COLEMAN A. YOUNG MUNICIPAL CENTER

Americans with Disabilities Act Accessibility Compliance Review Report

Detroit-Wayne Joint
Building Authority

FEBRUARY 2021

Evaluation Results

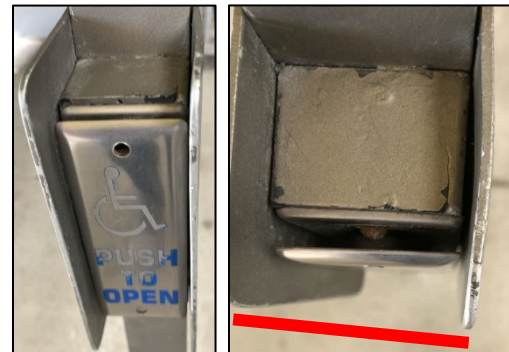
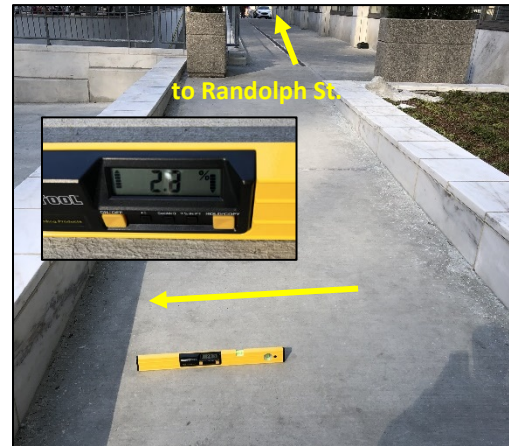
1. The employee parking lot provides a total of 44 numbered, assigned spaces, none of which are marked as accessible. Based on the parking count, 2 accessible spaces with access aisle would be required, including 1 that meets requirements for van-accessible spaces. Since spaces are assigned, consider the potential future need of providing compliant accessible spaces for an assigned user that becomes disabled and the necessary re-assignment of spaces to be compliant with ADASAD.

2. The ramp at the Larned Street entrance is compliant with all requirements for ramps and handrails.
3. A sloped access route that is less than 5% running slope on the Larned Street side east of the entrance, which connects to the Randolph Street entrance, has a cross slope of up to 2.8% (2% max. allowed). This accessible route could potentially be used by members of the public that mistakenly go to the employee-only Randolph Street entrance and are directed to the public Larned Street entrance.

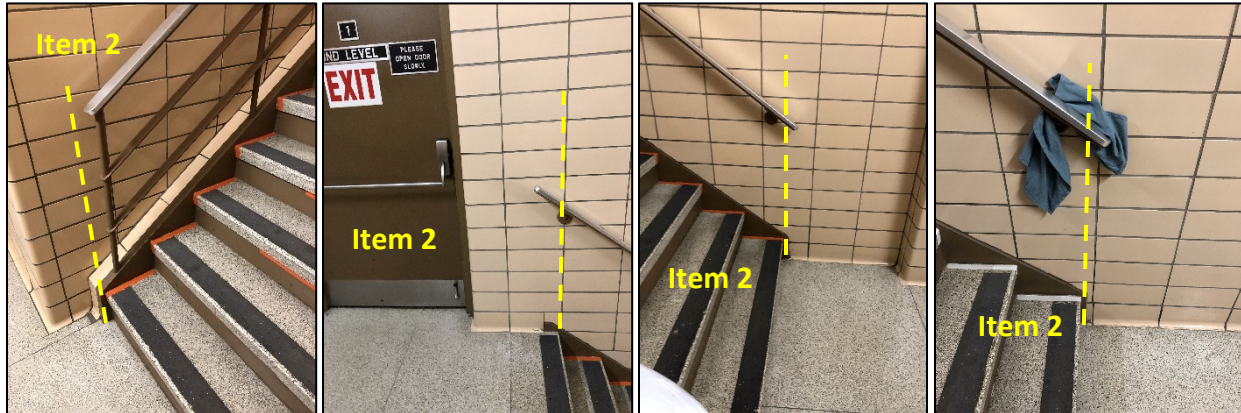
1. None of the public building exit doors provide both visual and tactile letters with Braille identifying the doors as a building egress or exit.

2. None of the five (5) stairwells have compliant handrails. Handrails lack the required extensions at the top and bottom and the height above the stair nosing to the gripping surface is below 34-38" required. This is not required to be corrected until the stairs are altered.

3. The stair nosings in all five (5) stairwells extend over the riser at a 90 degree angle, which creates a potential for a user's foot to catch and cause them to lose their balance. ADA standards require 30 degree maximum angle. This is not required to be corrected until the stairs are altered but is a safety item to consider.
4. Signage within the pre-security area informing the public that the accessible restrooms are available only in the lower level is of varied quality and desired location.

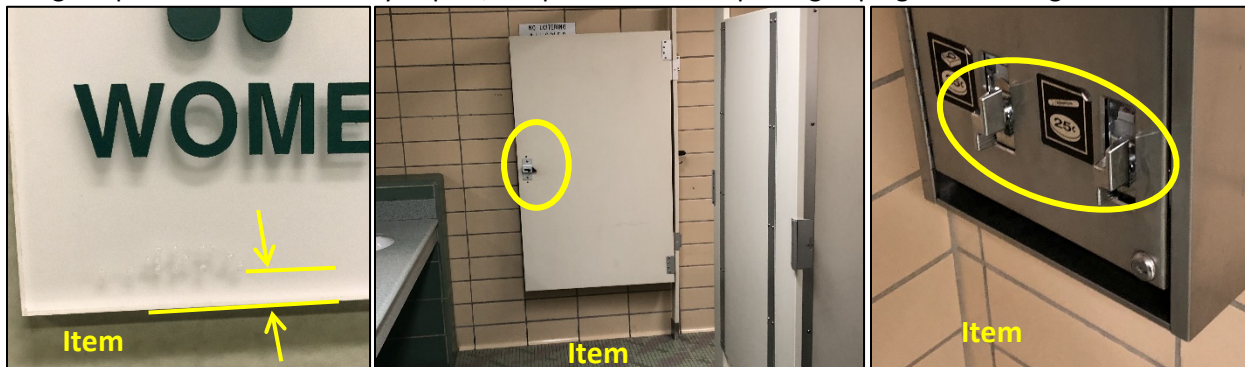
Examples of wheelchair user drinking fountains with bottle fillers that have been recently installed. Most have compliant height bubbler for wheelchair user compliance (36" max.) but some were installed with less than 27" knee space below and need to be reinstalled. The biggest compliance issues with these fountains is that they all protrude into the pedestrian circulation area since they were installed in original alcoves that are too shallow (Item 24).

25. Level 1 and 12 provide 2 drinking fountains each but neither meets wheelchair requirements for bubbler height or knee space and also have several other compliance issues for standing users.

26. Level 13 provides 3 drinking fountains, 2 of which are standing user height fountains original to the building have numerous non-compliance issues.

27. The wheelchair accessible fountain on Levels 2, 4, and 9 is mounted too low (most are 33"± bubbler), providing less than the minimum required knee space below of 27" and on Level 13 is mounted too high at 37" bubbler height. All need to be remounted to provide 27" min. knee space and 36" maximum bubbler height.

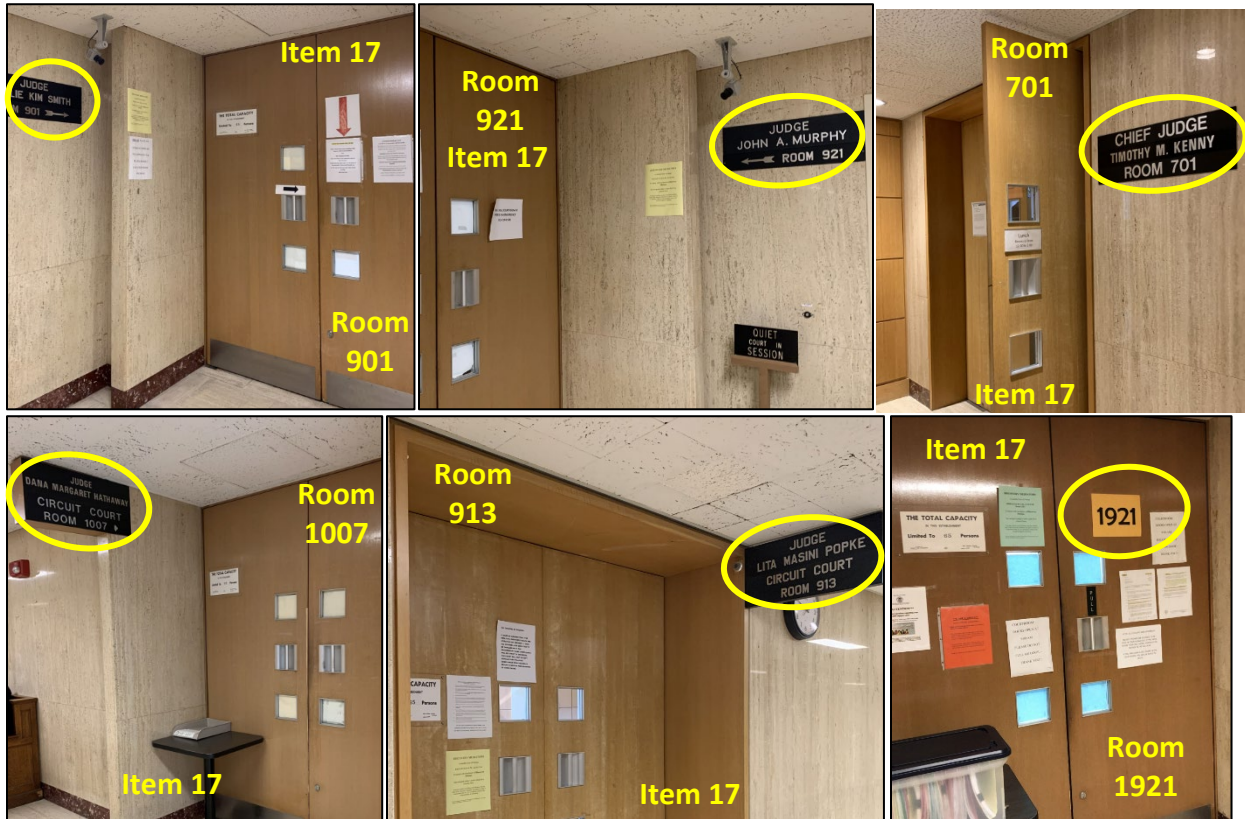
Examples of hallway doors accessing the stairway foyer that include information about other spaces also accessed from the foyer. Rooms 203 to Stair A & Room 205 to Stair B (left photo) are two of the few doors with visual text that a stairway is beyond the hallway access door. Door 1303 is the access from the corridor to the Stair A foyer but includes visual signage for Judge Braxton (center 2 photos). Photo on the right shows a typical stairway foyer in the Office Tower, with the stair access door and 1 or more other doors with or without signs (Item 5).

Examples of various non-compliant signage at courtrooms in the Court Tower (Item 17). Visual text signage is circled where it is present. Note the amount of visual text signage on many courtroom doors.

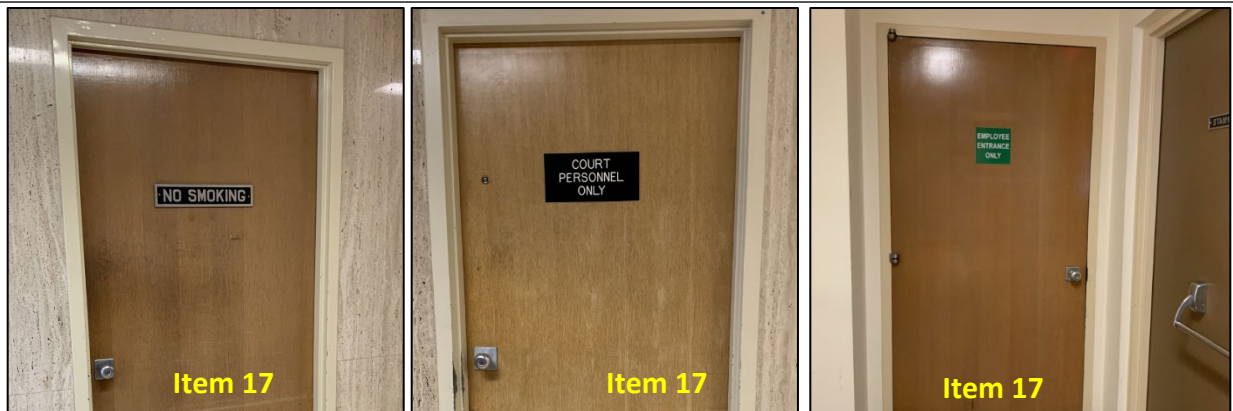
Examples of public and/or employee-only restroom with non-compliant or missing signage (Item 17).

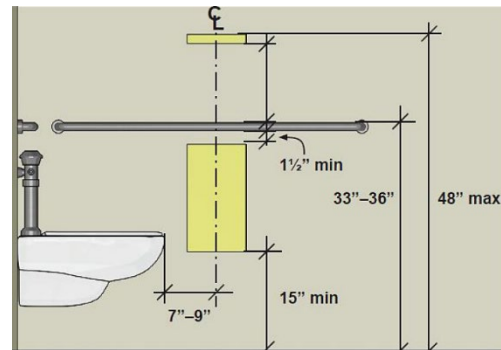
As discussed earlier, the only restrooms that are wheelchair-accessible and open to the public are located on the Lower Level of the Office Tower. Section 3.2 provides recommendations for signage at all restrooms within the CAYMC and directional and informational signage within the facility as well. The items noted below are the recommendations for the existing accessible restrooms to correct deficiencies noted during the facility evaluation, in addition to other recommendations to investigate options to provide additional accessible restrooms for the public. It is extremely unusual for a facility of this size to have only 1 wheelchair accessible restroom for each gender.

- The entry to both existing accessible restrooms is an open doorway. As part of the signage plan that is recommended for consideration, new restroom signage should be placed on both sides of open doorways at restrooms. This is primarily to reduce the potential for a blind person to inadvertently wander into the wrong gender restroom.

- Provide the required hardware on all wheelchair stalls, including compliant handles on both sides of the door and in the Women's restroom provide a functioning spring hinge that auto-closes the wheelchair stall door.
